Site Stabilization Work Plan -

Former East Alcoa Property

June 30, 2023

Geo-Technology Associates, Inc. (GTA), on behalf of Quantum Maryland LLC, has prepared the following Work Plan for site stabilization activities at the Former East Alcoa Property (“Site”). These activities are proposed to address concerns transmitted by the Water and Sciences Administration.

Figure 6

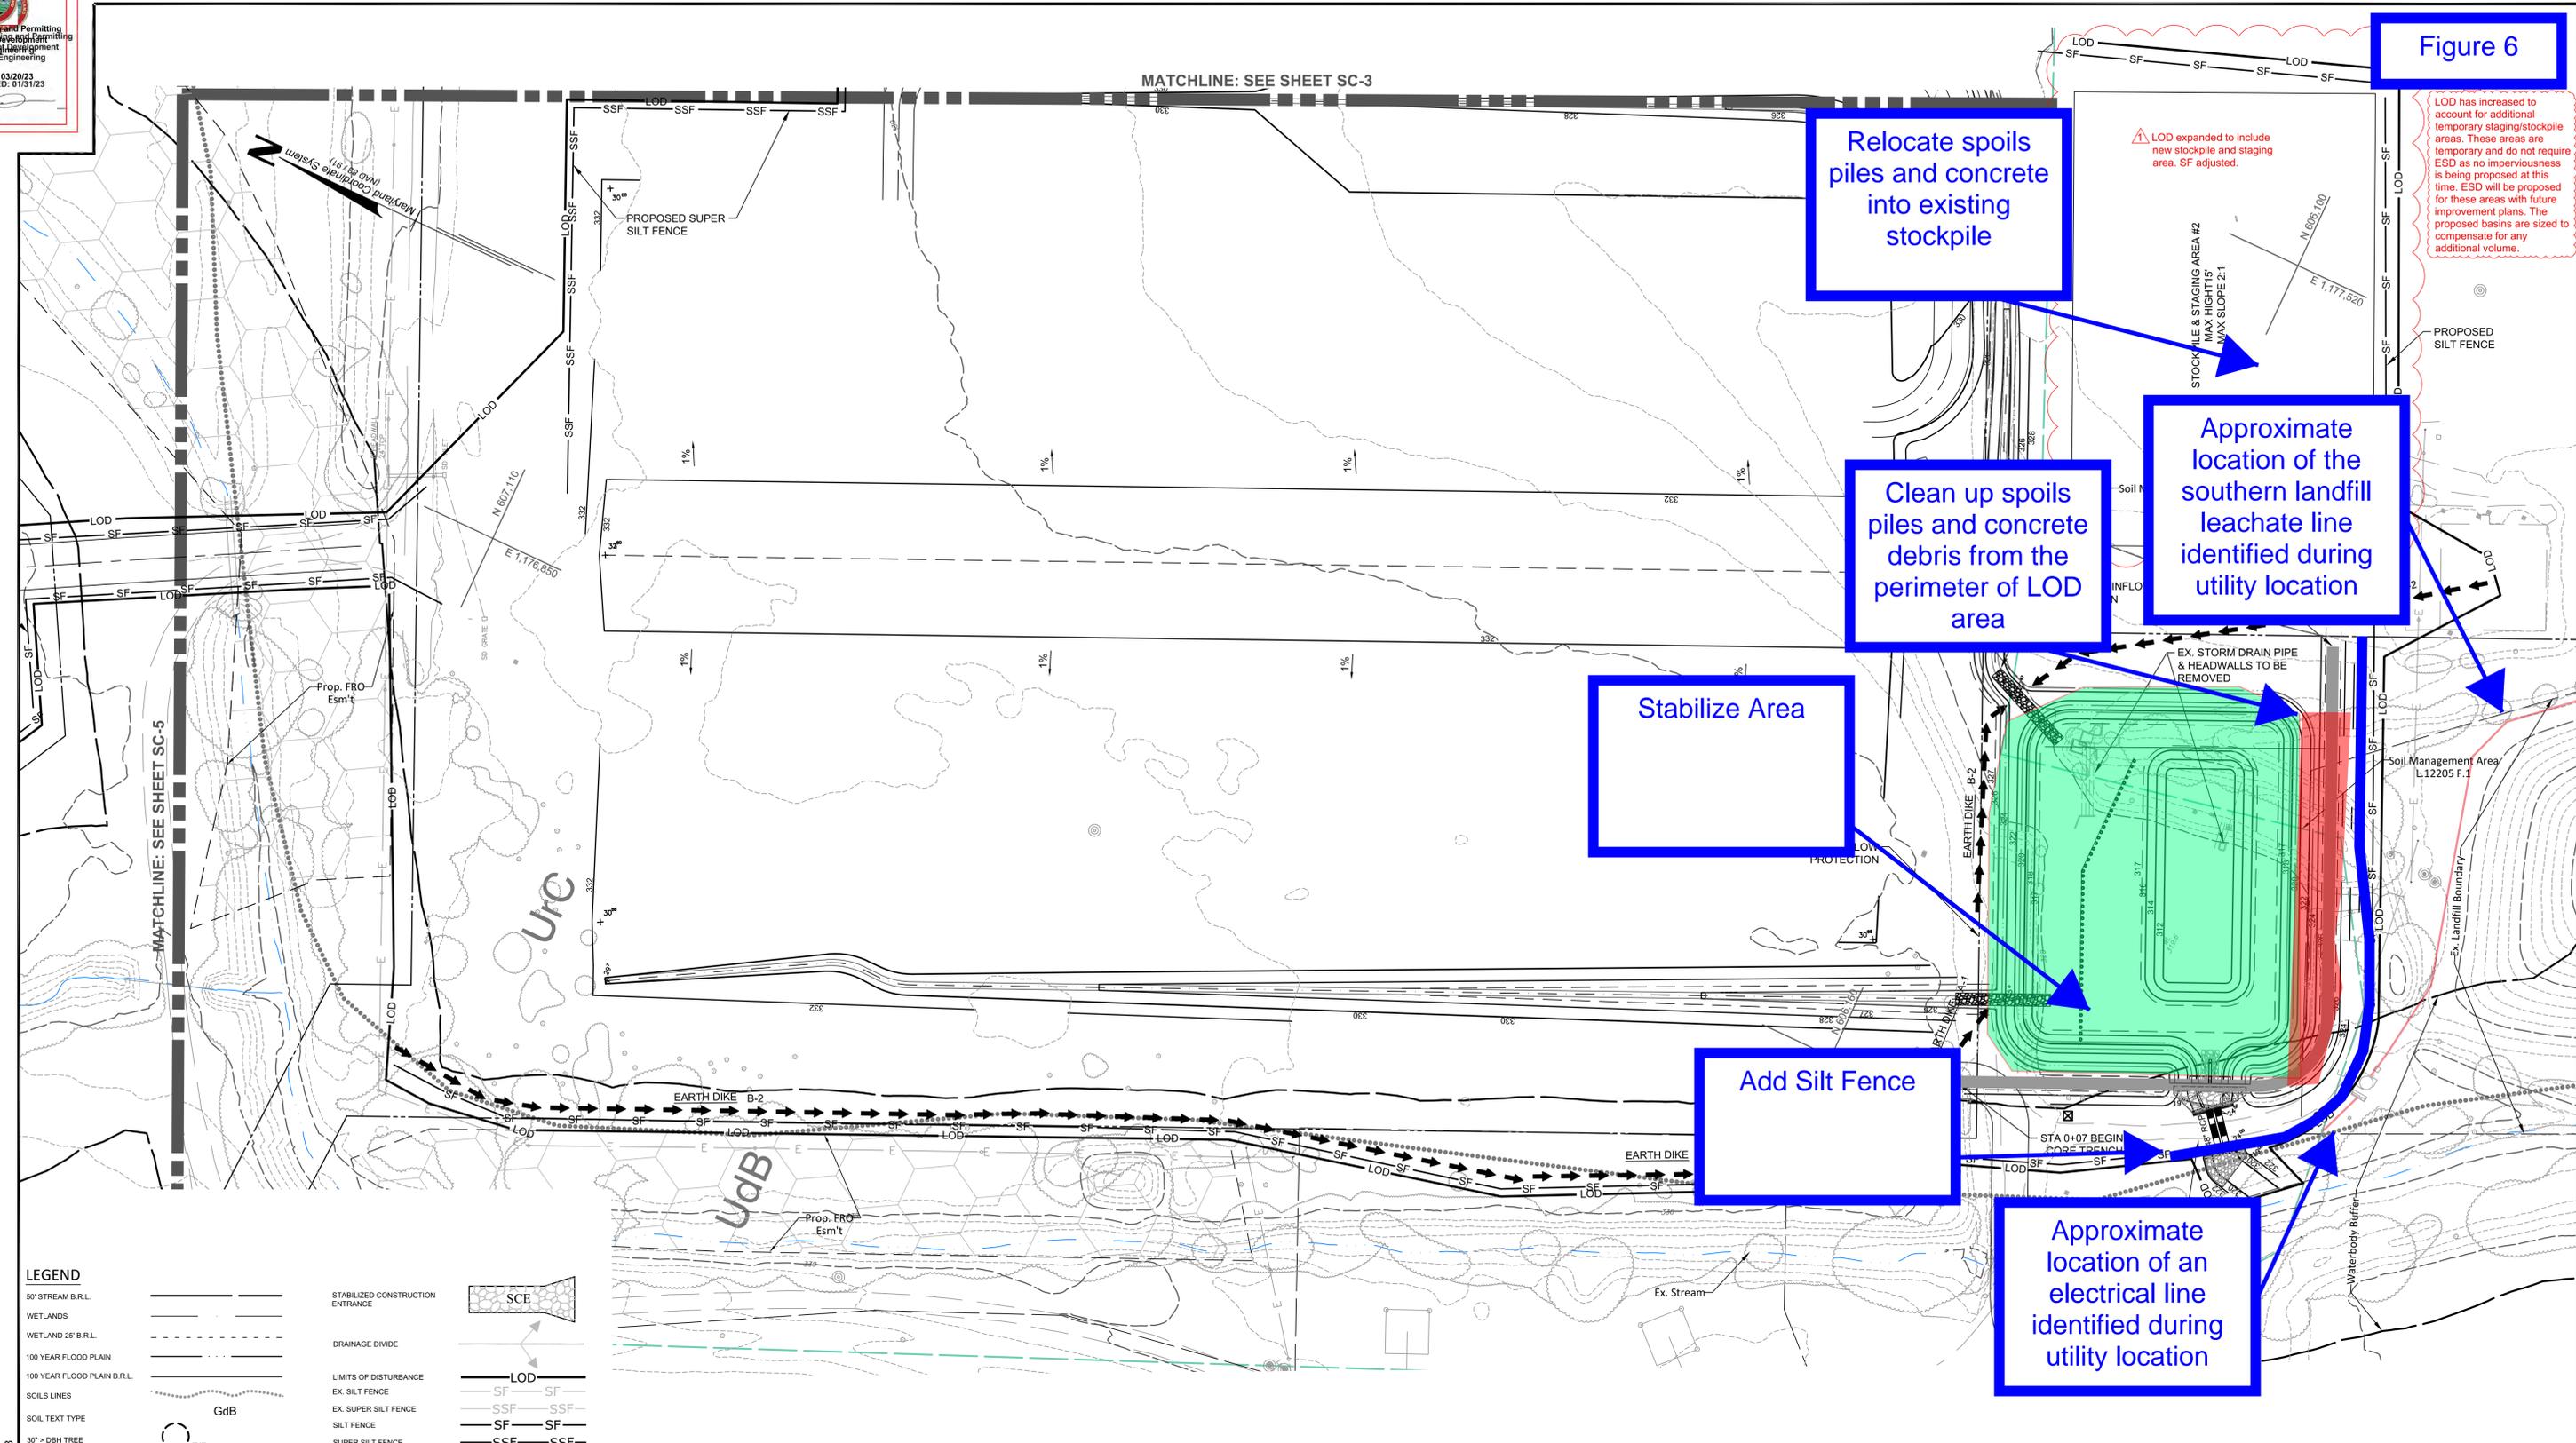
DA-11 Work – Disturbance previously occurred during the expansion of the former Rainwater Pond 102 to the proposed dimensions of the proposed DA-11 sediment basin. These activities resulted in the generation of concrete and soil spoils that are currently located along the southern portion of DA-11. The concrete and soil spoils are proposed to be relocated to a designated stockpile area east of DA-11 (see Figure 6).

the proposed development plans to locate the leachate line associated with the above referenced leachate collection system; and this leachate line is depicted on the attached Figure 6. The leachate line is as close as 7 feet from the limits of disturbance at the leachate collection system and increases to greater than 30 feet as the line progresses to the east and south.

Based on the proximity of electrical and leachate lines near the location of proposed work, a private utility locator was contracted to identify potential utilities in the proposed work area. On June 26, 2023, the utility locator identified and marked the electrical and leachate lines in the field. No additional utilities were identified proximate to the proposed work. The approximate electrical and leachate lines are identified on Figure 6.

After utilities were identified in the proposed work area, silt fencing was generally placed as show on Figure 6. However, some modifications to the silt fence installation were needed based on existing vegetation. These modifications to the silt fencing configuration were made since no additional ground disturbance is permitted at this time; however, the modifications did not affect the intent to provide a barrier between known disturbed areas and downgradient receptors.

Relocate spoils piles and concrete into existing stockpile

Clean up spoils piles and concrete debris from the perimeter of LOD area

Approximate location of the southern landfill leachate line identified during utility location

Stabilize Area

Add Silt Fence

Approximate location of an electrical line identified during utility location
